October 27, 2014

**Re: Official written comments from the National Biodiesel Board on the proposed Alternative Diesel Fuel (ADF) regulation presented October 20<sup>th</sup>, 2014.**

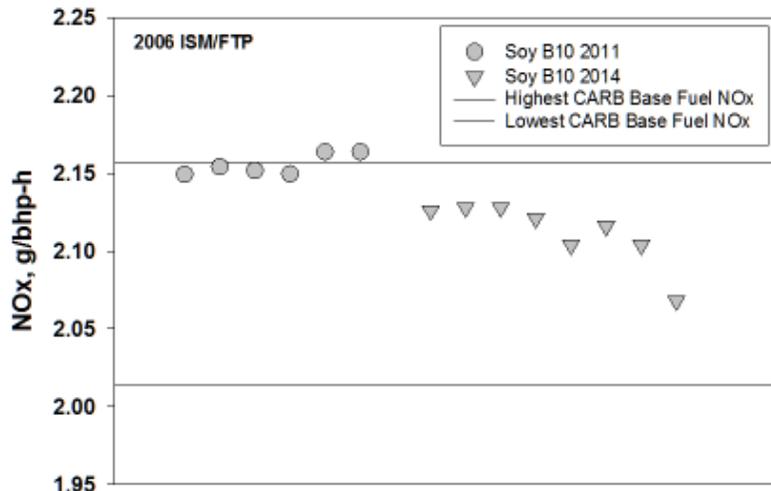
We believe the three studies that have been conducted on biodiesel should be combined to show the data in a more statistically powerful way. It seems less appropriate to base the regulation only on the most recent study. Below, we have included charts created by the National Renewable Energy Laboratory (NREL) of the ARB/Durbin data from 2011, 2013, and 2014. These plots show the emissions of biodiesel relative to the CARB certified diesel fuel tested.

**The chart below aggregates B10 test results from the 2011, 2013, and 2014 studies, illustrating that all except 2 of the 14 soy biodiesel data points are within the natural variability of the CARB certified diesel fuel tested. These points are outside the natural variability by 1/100<sup>th</sup> of a gram, far less than what is generally considered measurable.**
